MIL-F-18251C  
 AMENDMENT - 2  
 12 June 1970  
 SUPERSEDING  
 Amendment - 1  
 26 January 1968

MILITARY SPECIFICATION  
 FLUXES, WELDING, SUBMERGED ARC PROCESS  
 CARBON AND LOW-ALLOY STEEL APPLICATION

This amendment forms a part of Military Specification MIL-F-18251C, 24 October 1967, and is mandatory for use by all Departments and Agencies of the Department of Defense.

Figure 1 - Groove weld test plate. p. te

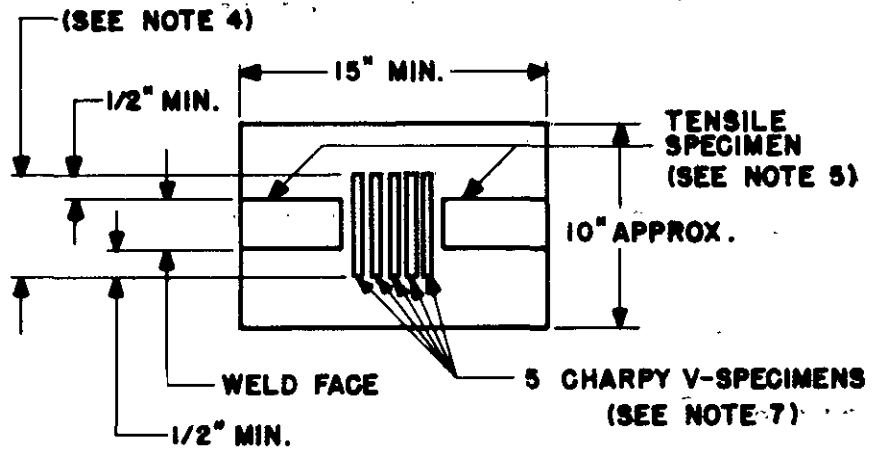
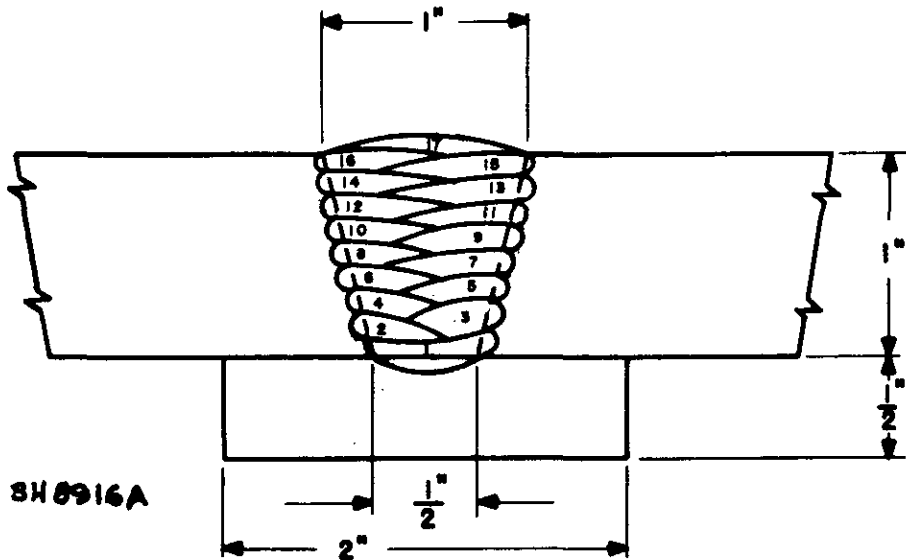
Figure 1: Delete and substitute the attached figure.
